# INDEPENDENT EXPERT ADVISORY PANEL FOR MINING

## **MOOLARBEN COAL COMPLEX OC3 Extension Project (SSD-330833580)**

**Report No: IEAPM 202504-01**

Figure 4: Transect/plot data from EcoLogical (2023) showing the relationship between exotic perennial cover (x axis) and vegetation integrity score (y axis).

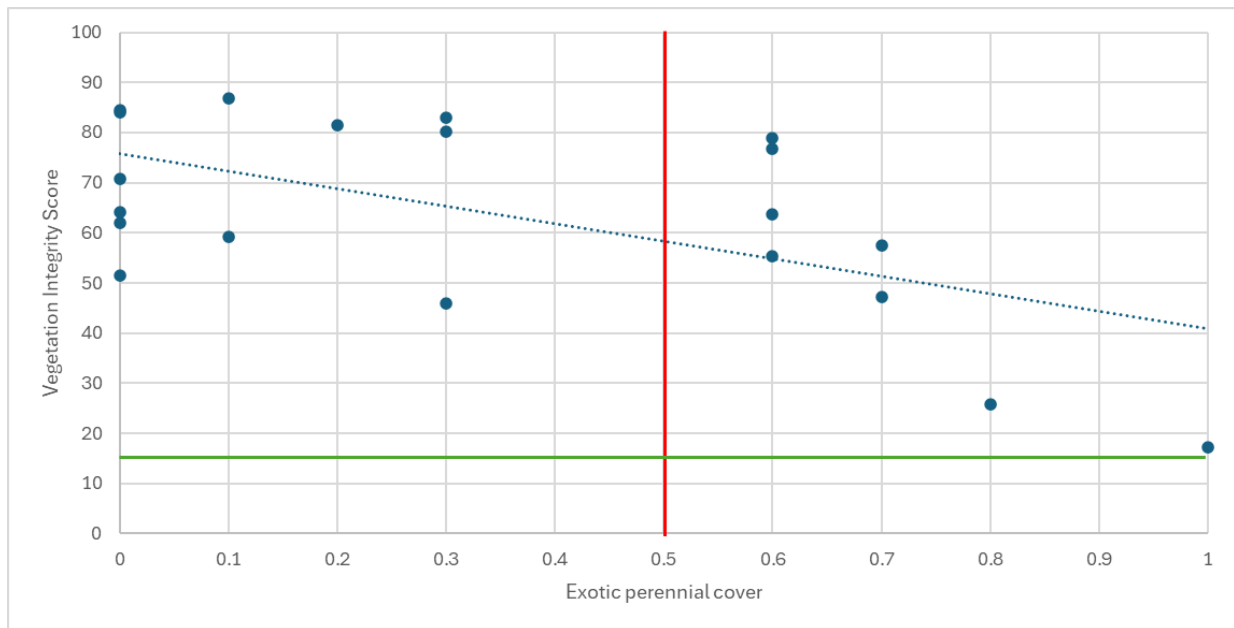
In its letter to the Department, DCCEEW (2025) contends that if the CEEC, as described in the final determination (TSSC 2020a), currently persists then the precautionary principle should apply, the land should be mapped as the CEEC and the BAM (DPIE 2020) should be applied. DCCEEW's argument appears to be centred around the ability of the CEEC to be recovered. DCCEEW (2025) points to data from EcoLogical (2023) which shows that none of the transect/plot data collected by EcoLogical (2023) resulted in a vegetation integrity score below the threshold for which an assessor is not required to determine an offset for ecosystem credits (Section 9.2 of the BAM, DPIE 2020). Figure 4 shows that while there may be a relationship between exotic perennial cover and the vegetation integrity score, land considered low conservation value grassland under IGGAM (OEH 2017) does not always fall below the threshold for offsetting set out in the BAM (DPIE 2020). It is noted that plot data collected by Niche (2024a) either had a perennial exotic cover of >50% or a vegetation integrity score of <15.

Points to the right of the red line are considered low conservation value grassland and Category 1 land in accordance with IGGAM (OEH 2017). Points below the green line do not require offsetting under Section 9.2 of the BAM (DPIE 2020).

Figure 5: Category 1 land mapping from the draft Native Vegetation Regulatory Map overlain (in blue) with Category 1 land mapping by Niche (2024a) (in grey striping) as shown in Figure 2 of Hunter Eco 2024a.

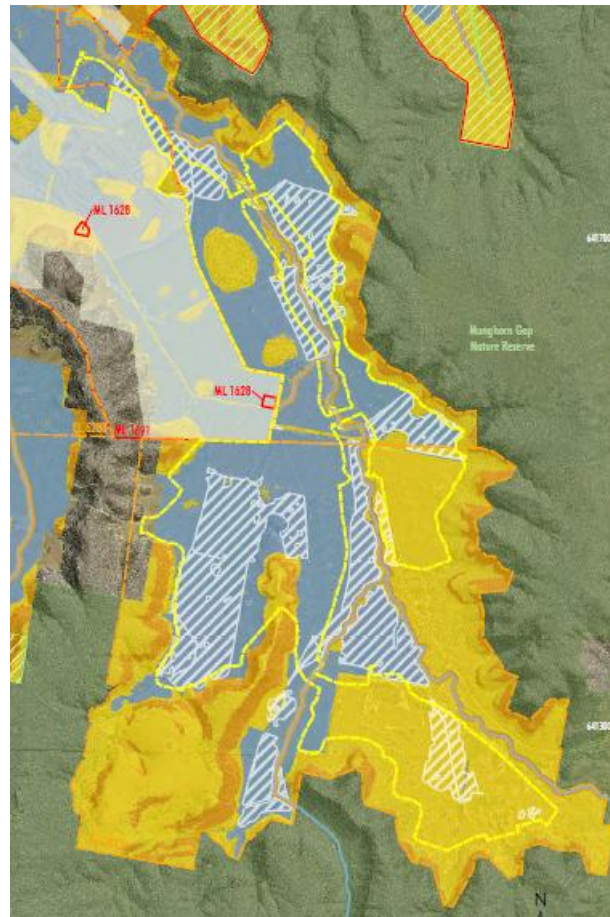
- The mapping of Category 1 land in Niche (2024a) is generally less extensive than shown in the draft Native Vegetation Regulatory Map, although some additional area in the south-east of the project (Figure 5).

Figure 6: Avoidance of impacts to Box Gum Woodland from the Original Project (source: Figure ES-6 of Yancoal 2024c). Areas of avoidance are shown

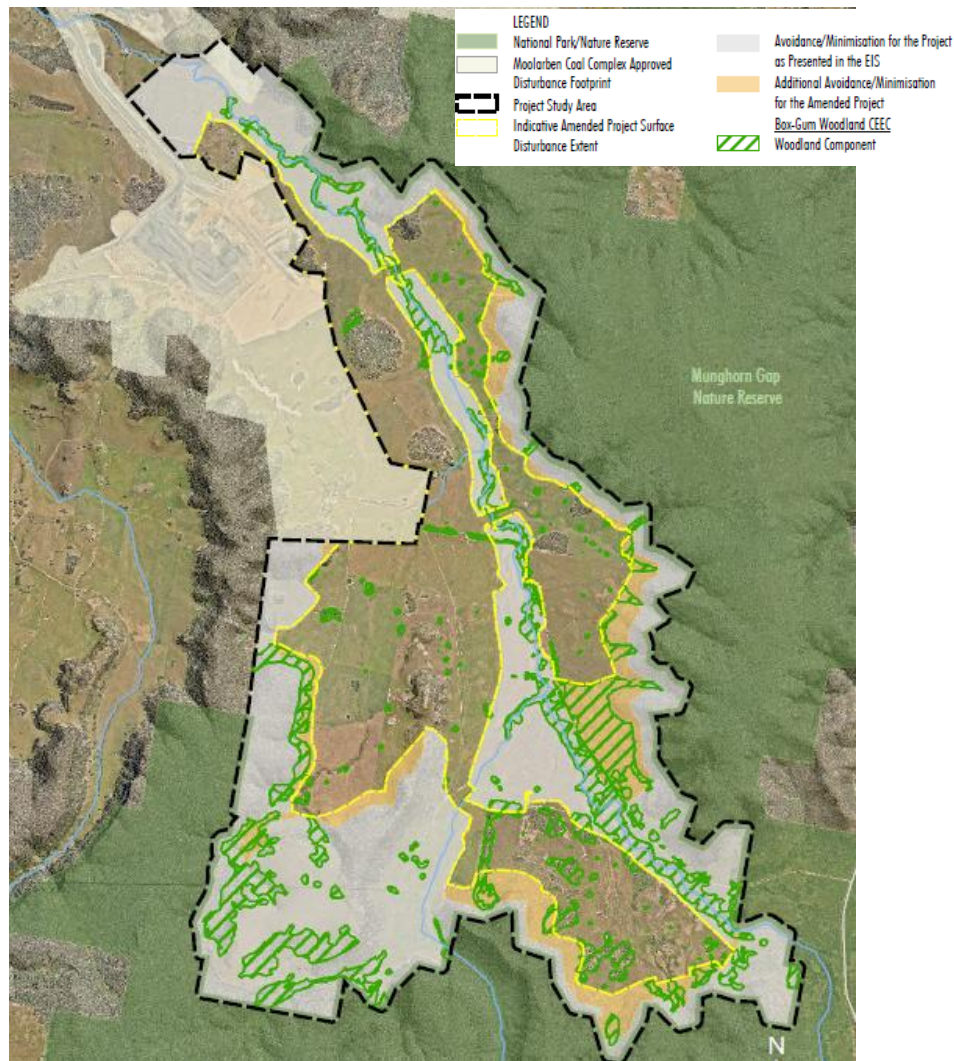
DCCEEW (2024, 2025) believe additional measures to avoid impacts are required, particularly in the south-eastern area of the project. The south-eastern area is mostly comprised of an open pit, with a haul road and stockpiles. Without severely reducing or even removing the open pit extent, further avoidance in this area would be practically challenging.

Figure 8: Bat roosts adjacent to the development footprint (source: Figure A-1 of Attachment A of Yancoal 2025b)

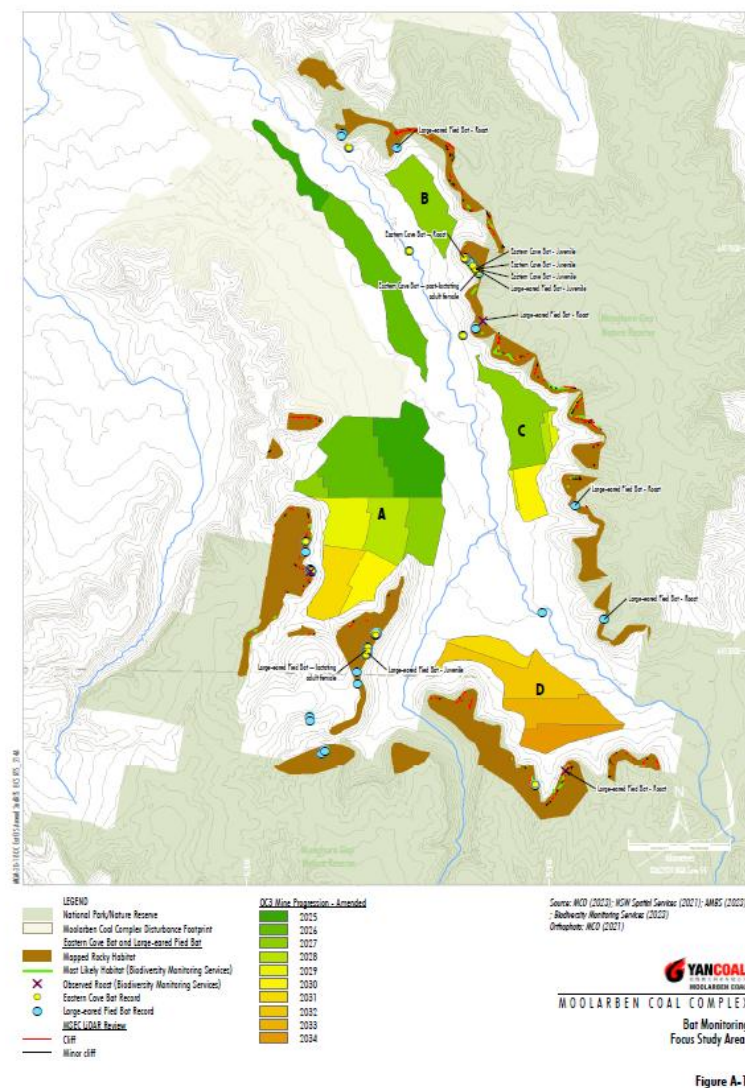
Of particular concern to the Panel are the seven bat roosts identified in Figure 8. The performance measure outlined above aims to avoid physical damage to rocky habitats, and this is critical for any breeding roosts given the irreplaceable nature of such habitats. However, there is potential for blasting to result in behavioural impacts to microbats. The Panel is not aware of any studies on the behaviour of microbats in relation to blasting other than Martin (2015) which documented no disturbance of bats in a maternity roost at vibration levels of 12 mm/s; however, this is well below the 50 mm/s proposed. Of particular concern would be disturbance to breeding roosts during the breeding season and other roosts when the species are in torpor. Biodiversity Monitoring Services (2024) states that blasting has potential to lead to reduced use of roost sites, but that any impacts would be temporary.

The bat monitoring program proposed in the summary of the proposed blast management plan (Attachment A of Yancoal 2025b) outlines a broad concept for monitoring program, but this program lacks any detail on proposed monitoring type and locations. The Panel is of the view that a trigger action response plan (TARP) for blasting activities should be developed and should include triggers for both physical damage to rocky habitat as well as triggers for behavioural impact to microbats.

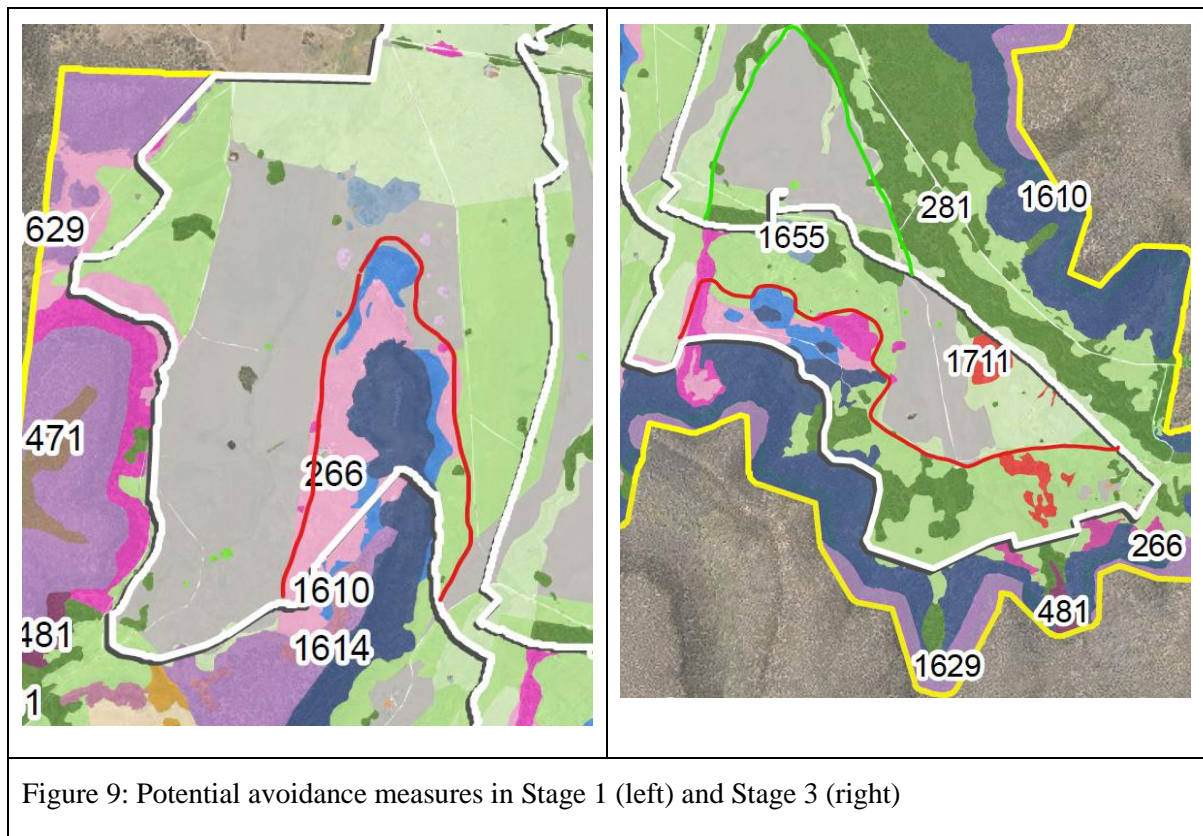
That said, two key areas where avoidance may be feasible and warranted are shown in Figure 9 below:

- Avoidance of the additional areas of Stage 1 shown in Figure 9 would avoid impacts to Box Gum Woodland in DNG condition, PCT 1610 in High and Regenerating condition, along with habitat for the Pink-tailed Legless Lizard, Swift Parrot, Regent Honeyeater, Koala, Squirrel Glider, Large-eared Pied Bat (foraging) and Eastern Cave Bat (foraging).
- Avoidance of the additional areas of Stage 3 shown in Figure 9 would avoid impacts to Box Gum Woodland in High and DNG condition, PCT 1610 in High and Regenerating condition, PCT 1711 in High condition, along with habitat for the Pink-tailed Legless Lizard, Swift Parrot, Regent Honeyeater, Koala, Squirrel Glider, Large-eared Pied Bat (foraging) and Eastern Cave Bat (foraging).
  - This could be compensated for by extending the layout into the areas shown in green in Figure 9, subject to the suitability of the coal resource in this area.

- adaptive management measures should either the physical damage or behavioural performance measures be exceeded.
- The Department and/or the IPC may wish to determine whether further avoidance of impacts in Stages 1 and 3 (as shown in Figure 9) are warranted to avoid impacts to Box Gum Woodland and habitat for threatened species.

Figure 10: Surface Monitoring Network (Figure 11 from Yancoal 2022)

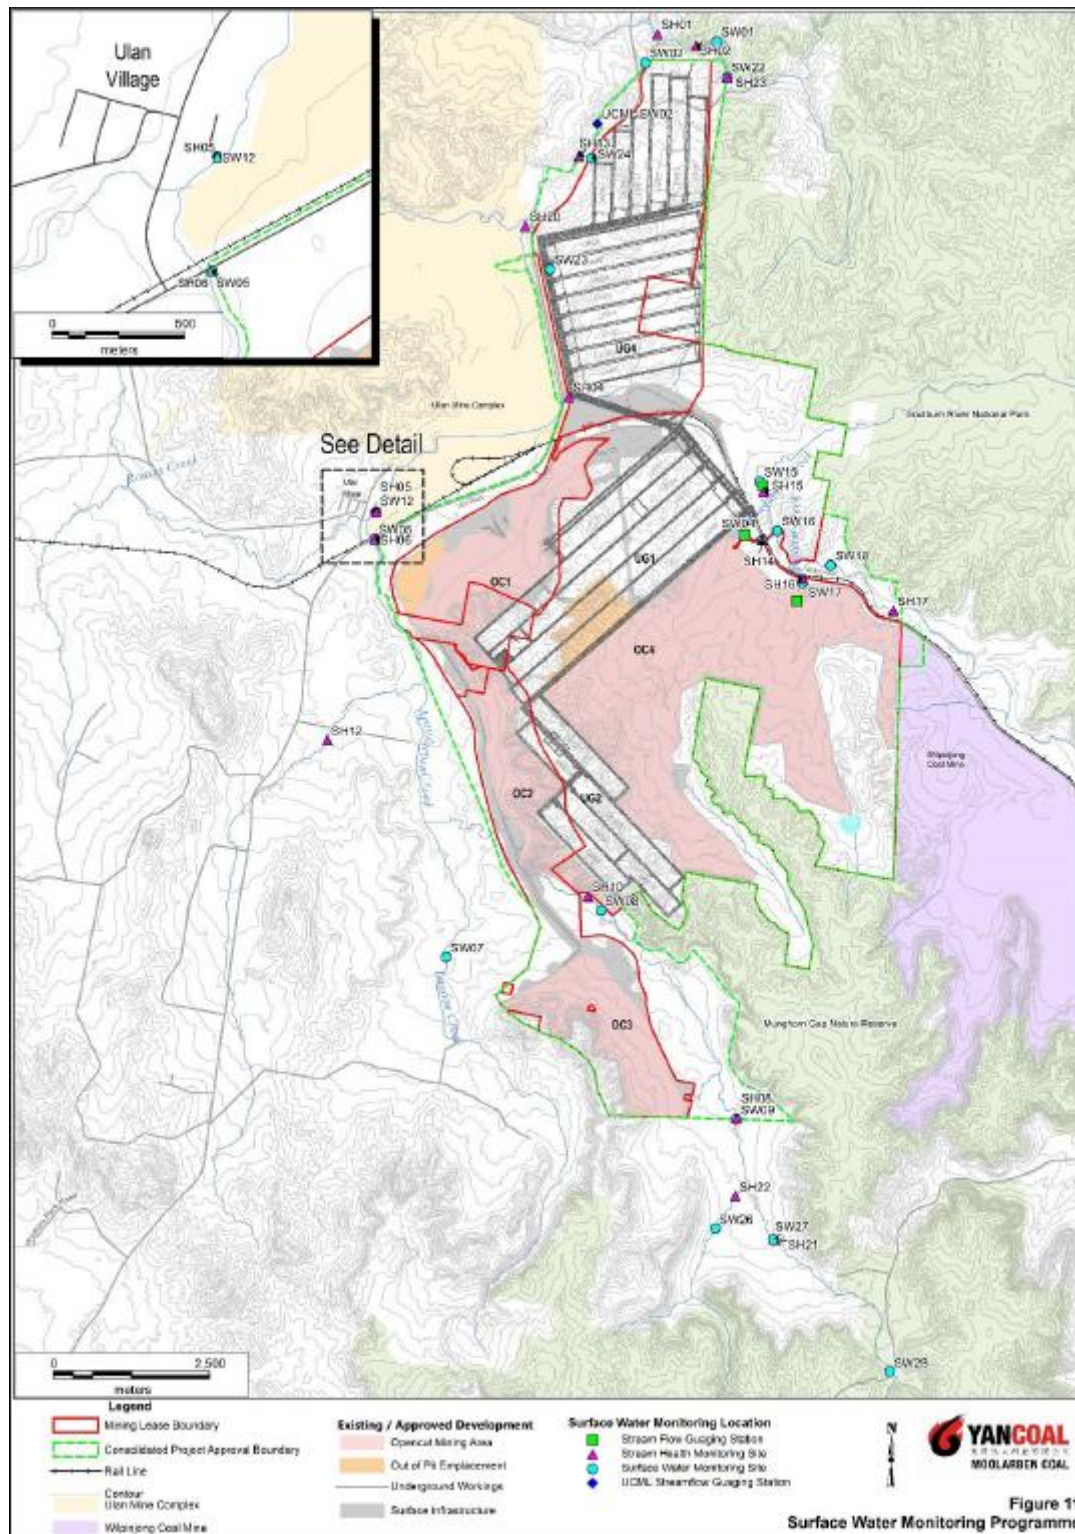
The current surface water monitoring program is shown in Figure 10. There are two surface water monitoring sites along Moolarben Creek (SW08 and SW09) both of which are quality monitoring sites, not flow gauging sites (WRM 2022). Murdering Creek is also an ephemeral creek and does not have any flow gauging infrastructure (AGE 2022). There is no existing or planned surface water flow monitoring in the extension project area. The closest gauging station is SW01, on the Goulburn River, which is operated by Ulan Coal. The Panel considers the lack of flow gauging infrastructure is a non-

The Panel concludes that the number of surface water monitoring sites and the planned water quality and aquatic health monitoring at these sites is appropriate for assessing potential impacts on surface water quality and biodiversity health.

It is recommended that surface water TARPs are developed that specifically relate to the surface water monitoring planned in the vicinity of OC3. The Panel recommends that the SWMP is updated after 18 months of baseline data is collected at SW08 and SW09 so that recent data can be used to inform trigger levels for these surface water TARPs. This will allow investigations to be triggered when the surface water quality downstream of OC3 exceeds appropriate trigger levels.

Figure 11: Groundwater Monitoring Network (Figure 25 from AGE 2024)

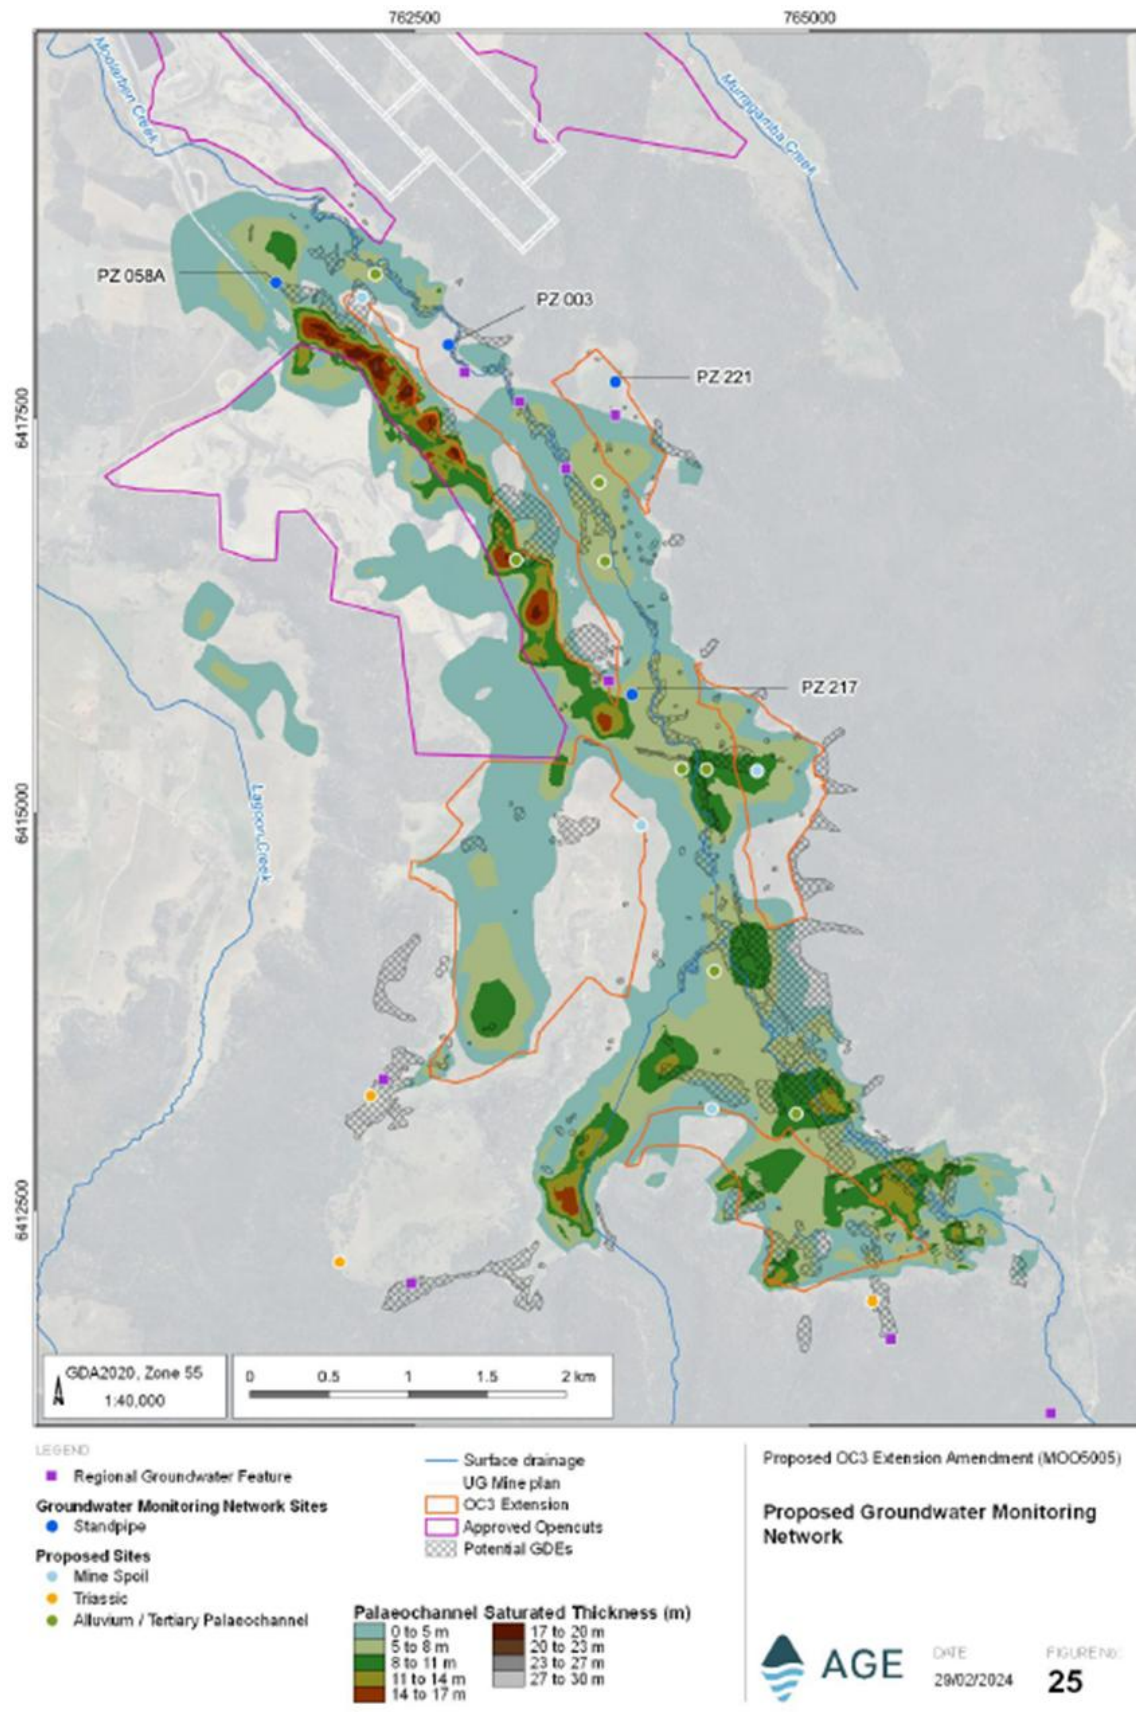
The proponent committed to the installation of new monitoring bores in 2024 (Yancoal 2024a) however the Panel understands that no new monitoring bores have been installed as at the date of this advice. The proposed sites are shown on Figure 11 and described in Section 8.2 and Table 8.1 of AGE 2022 and include:

The Panel agrees that, for the purpose of improved groundwater model calibration and validation, and TARP compliance, the proposed monitoring network in AGE 2022 will provide improved spatial coverage. Nevertheless, the program would also benefit from:

- Several nested monitoring (standpipe) sites that are paired with alluvial monitoring sites in the Moolarben Creek buffer zone to monitor water levels in the deeper Permian overburden (if present) and/or Ulan coal seam.
- A deeper VWP sensor in the Permian overburden at two of the three Triassic sandstone monitoring sites to monitor regional groundwater depressurisation.
- Monitoring of the nine ‘regional groundwater features’ shown Figure 11. For those features that are springs, monitoring of flow, field water quality, and the composition/health of any dependent vegetation is recommended.

Data from these sites is at best useful for assessing the depressurisation impacts of the current mining activities, however the data set does not provide sufficient spatial coverage to assess local groundwater impacts in the southern portion of the OC3 extension project area.

- Monitoring of the nine 'regional groundwater features' shown Figure 11. For those features that are springs, monitoring of flow, field water quality, and the composition/health of any dependent vegetation.

Figure 12: Hydrograph for alluvial monitoring bore PZ058A

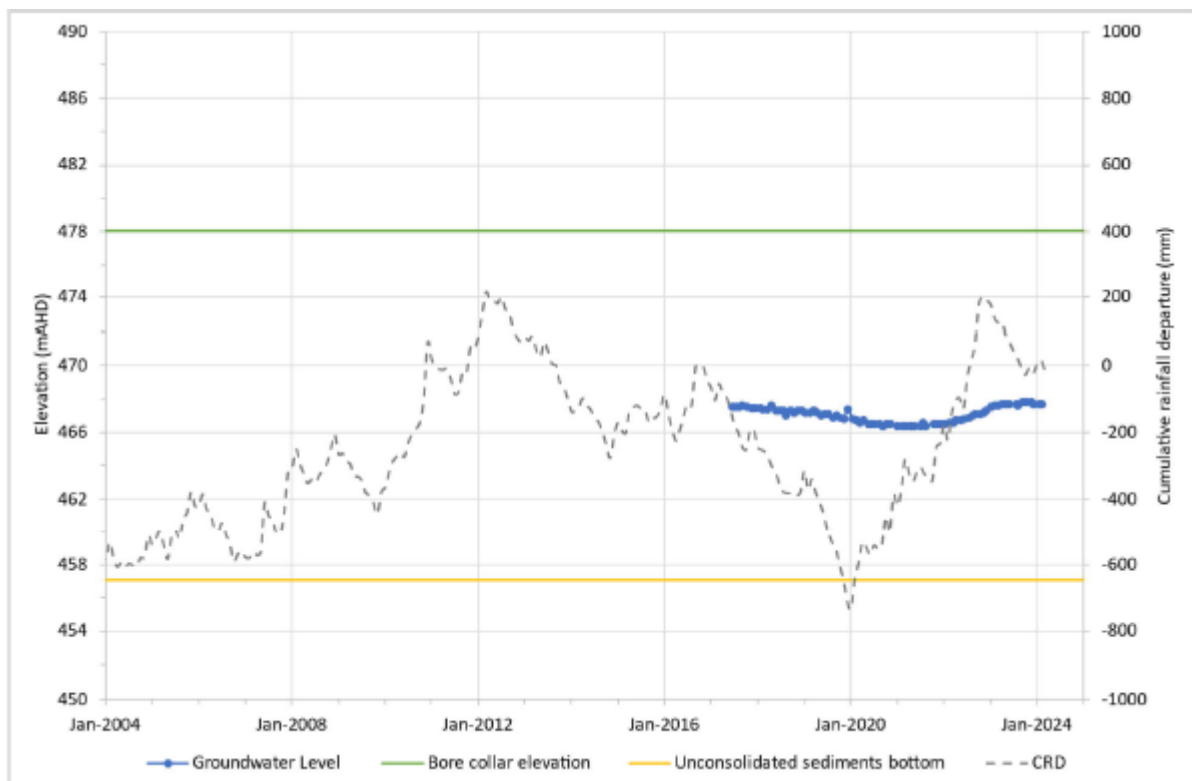
Historic water levels have approached the low water level trigger in recent years (see Figure 12).

This site and these triggers are of no use in protecting the (groundwater dependent) riparian terrestrial vegetation along Moolarben Creek. Additional alluvial standpipe locations need to be nominated as trigger locations and new TARPs for both water levels and water quality determined once sufficient baseline data is available to ensure there is sufficient saturation in the buffer zone areas of the creek alluvium and the palaeochannel area to sustain these GDEs. The Panel recommends that the GMP is updated after 18 months of baseline data is collected and available from the expanded alluvial monitoring bore network.

- Update the groundwater management sub-plan within 18 months of the installation of the new monitoring bores, and include:
  - at least two of the new alluvial monitoring locations as water level and water quality trigger locations, and use baseline monitoring data from the first 12 months to determine new trigger water levels and water quality thresholds, and
